**RECORD DRAWING**

No.	Revision	By	Date
	AVALON PARK-PHASE 5		
	<b>SITE GRADING PLAN</b>		
	JAMES L. ARMOUR, P.E.-CITY ENGINEER CITY OF WICHITA PROJECT NO. 472-83839		
	<b>Professional Engineering Consultants, P.A.</b> 303 S. TOPEKA - WICHITA, KANSAS 67202 316-262-2691 • FAX 316-262-3003		
Designed by	BDB, BLB	Job No.	35-05060-000
Drawn by	BJS	Date	February 2005
			SH. 5 of 22

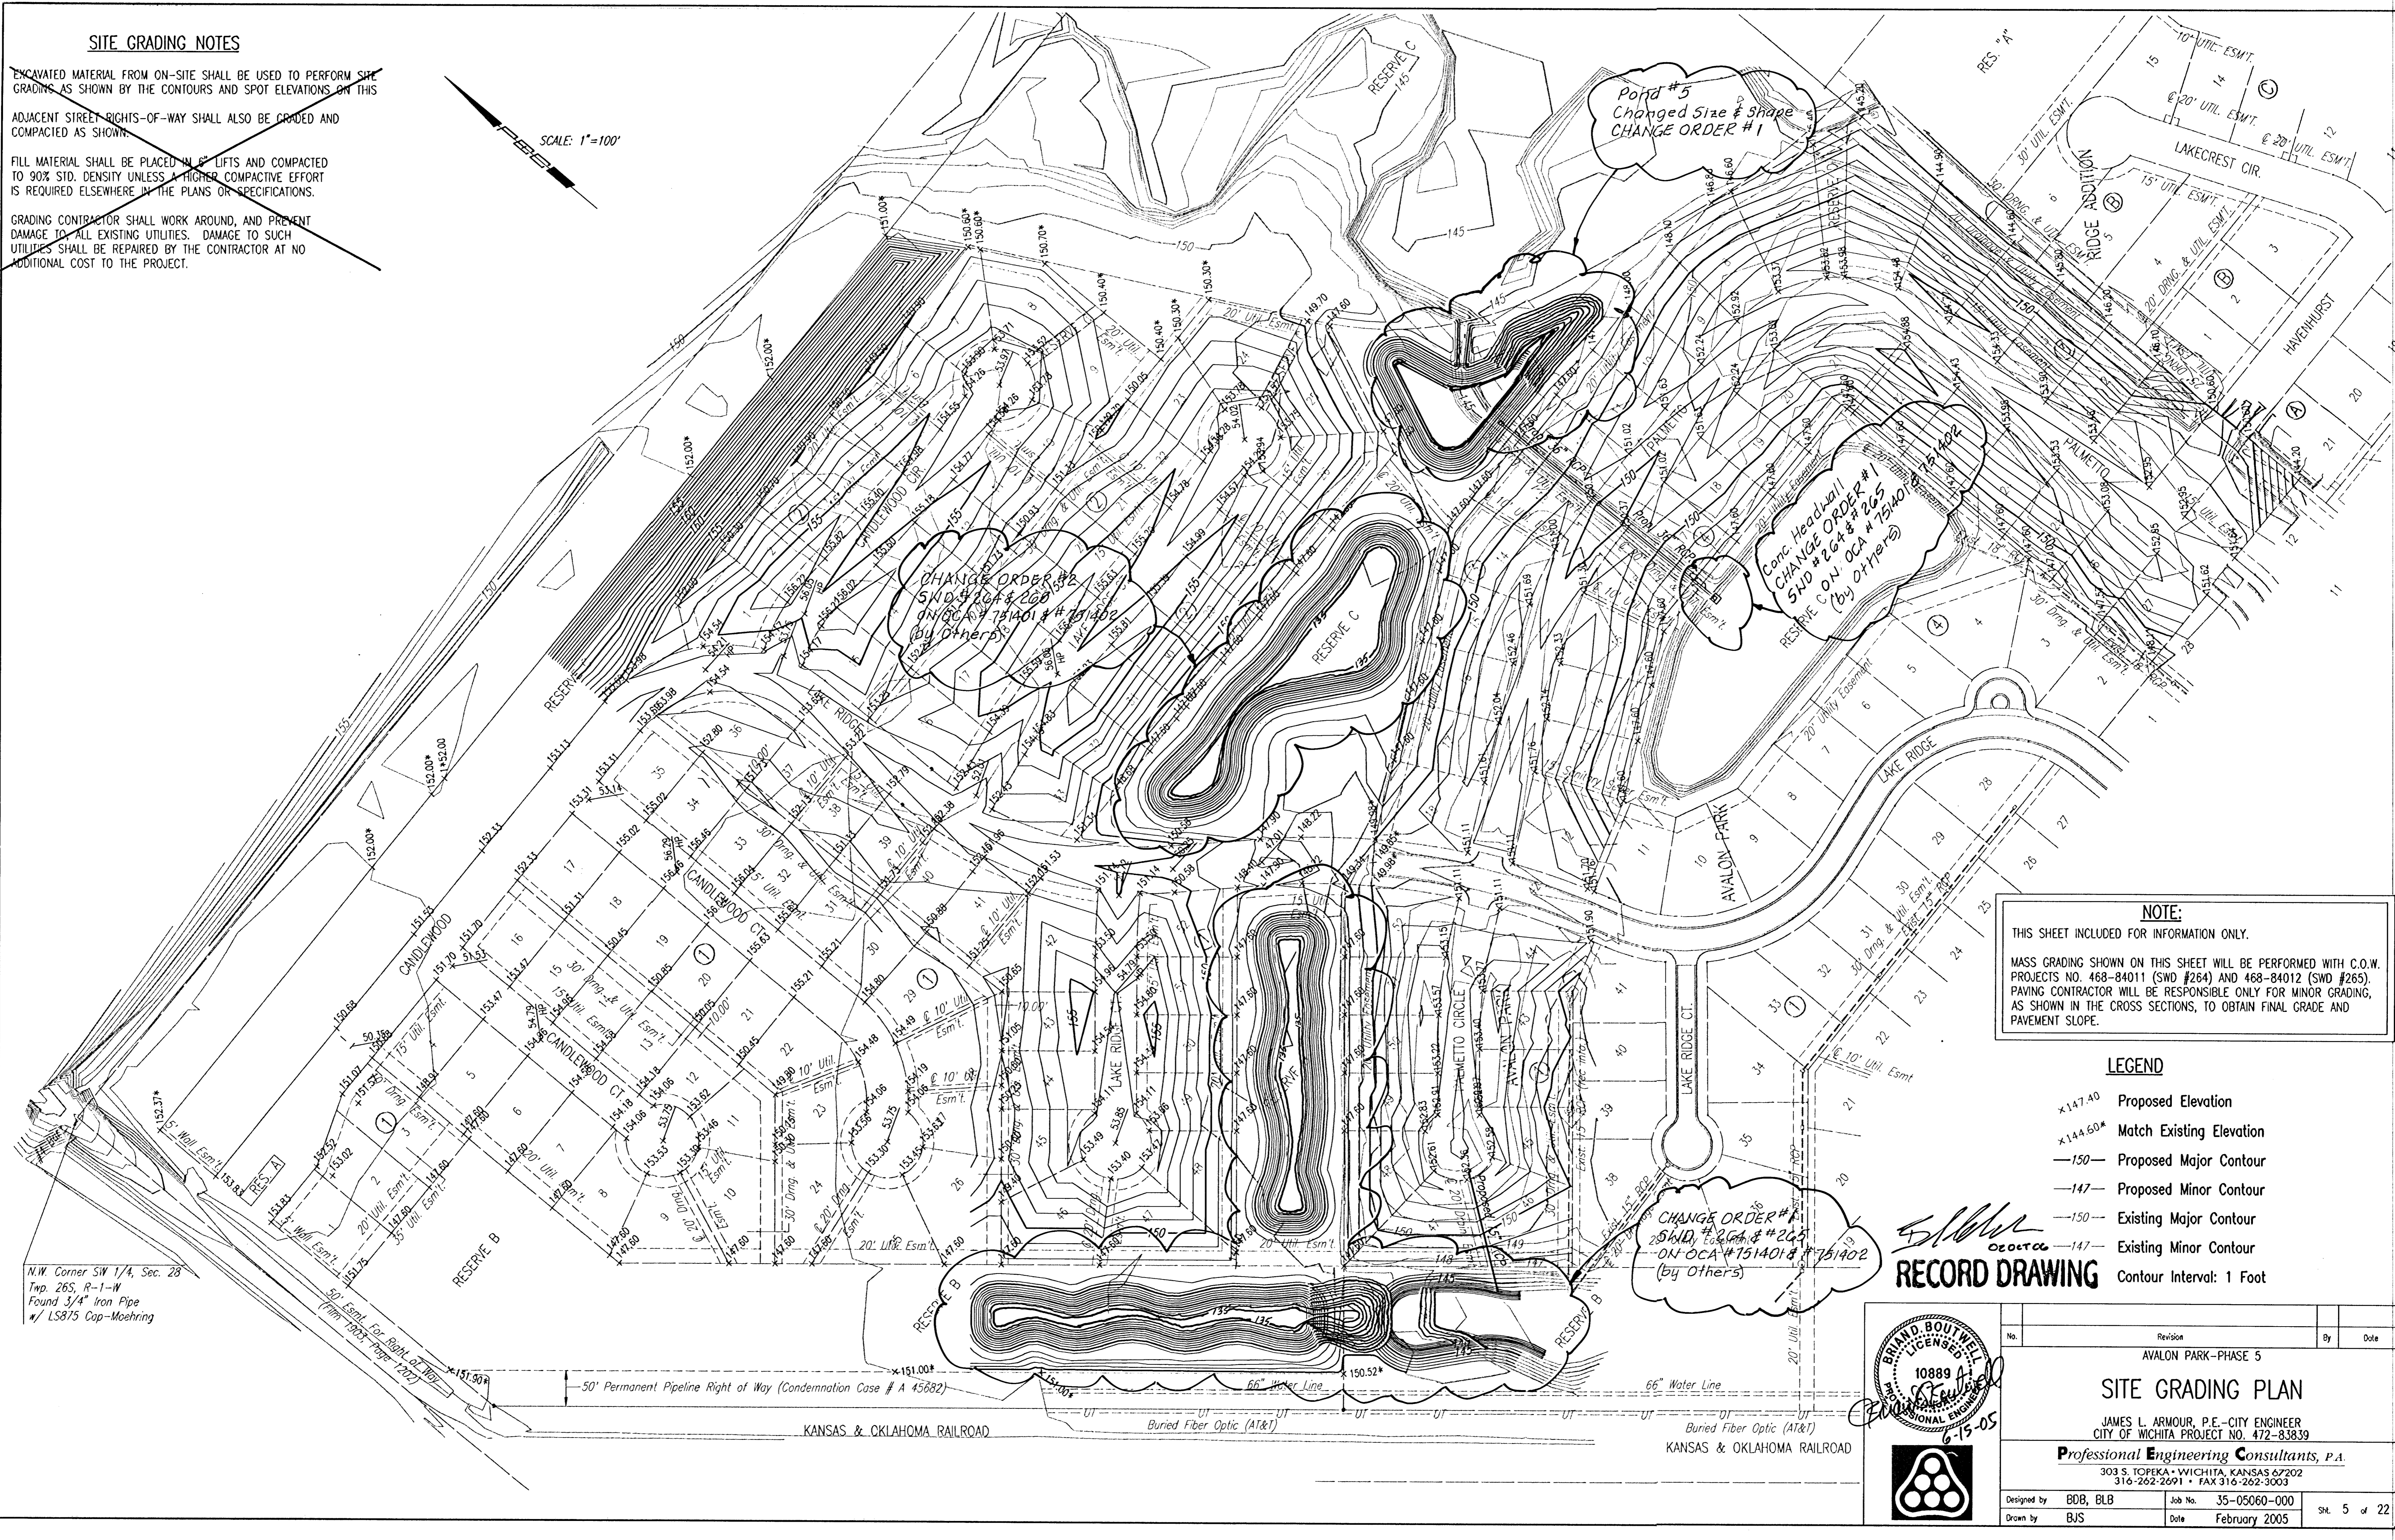
Point #5  
 Changed Size & Shape  
 CHANGE ORDER #1

CHANGE ORDER #2  
 SWD #264 & #265  
 ON OCA #751401 & #751402  
 (by Others)

Conc. Headwall  
 CHANGE ORDER #1  
 SWD #264 & #265  
 ON OCA #751401 & #751402  
 (by Others)

CHANGE ORDER #3  
 SWD #264 & #265  
 ON OCA #751401 & #751402  
 (by Others)
